PCN/22/013/C+N-US

Product Range: Han-Modular

Date: 06/14/2022

Title: Han® Megabit Module 1 cable entry

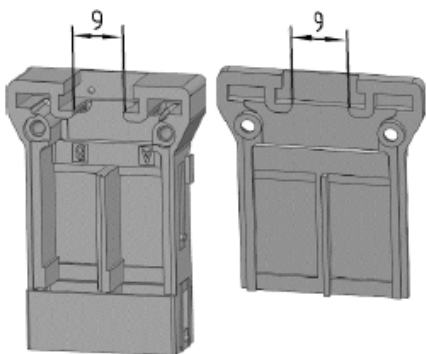
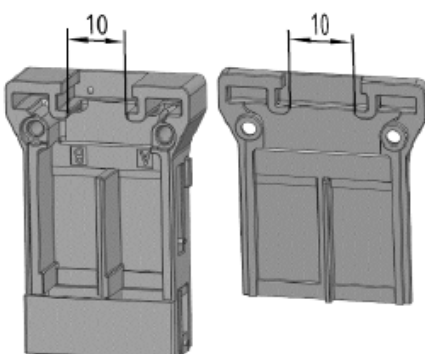
1. Concerned Part Numbers	
09140083021	09140083022
09142083021	09142083022
09140083121	09140083122
09142083121	09142083122
2. Description of Changes/News	
The Han® Megabit module cable entry inner width will be enlarged from 9mm to 10mm width. Current Megabit module with cover  New Megabit module with cover  Additionally, the sharp edges of the inner contour will be smoothened a little to improve the handling	
3. Impact on Product Specification	
This modification has no impact on specifications or handling.
